## Addendum for Updated EPP / Master Key Loading

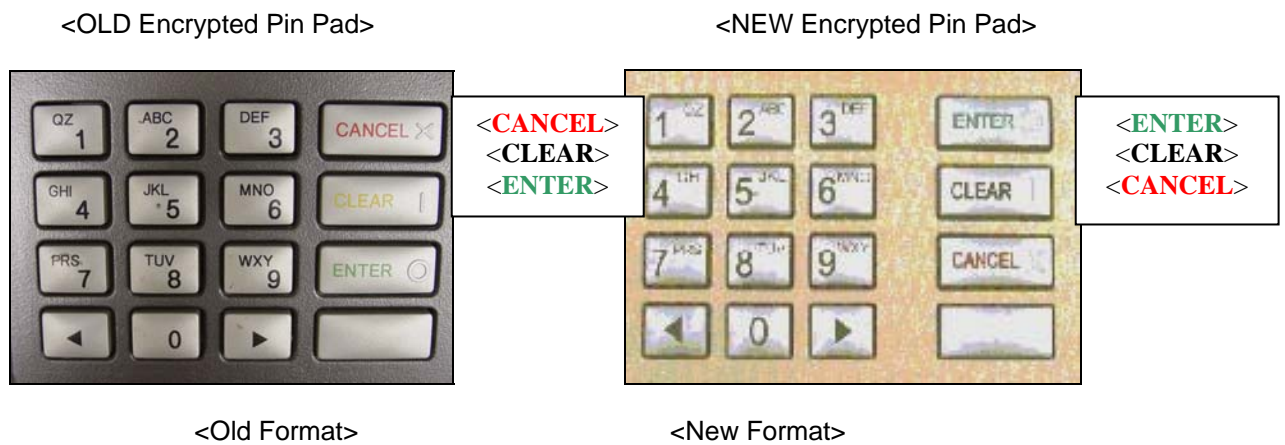
There are two different Tranax pin pad styles. The principle difference between the two is the placement of the ENTER and CANCEL keys. They are switched. The new style pin pad has the ENTER key on the upper right hand corner of the keypad. The old style had the CANCEL key in the upper right hand corner.

One of the effects of this new configuration is a change in how master keys are entered. The old format (see below on left) had the D in the top right position and the F in the third from top position. The new format (see below on right) has the F key in the top right and D in the third from the top position.

New keypad serial number will begin **OAFIxxxxxx** (old style is OACIxxxxxx) These two parts are not interchangeable.
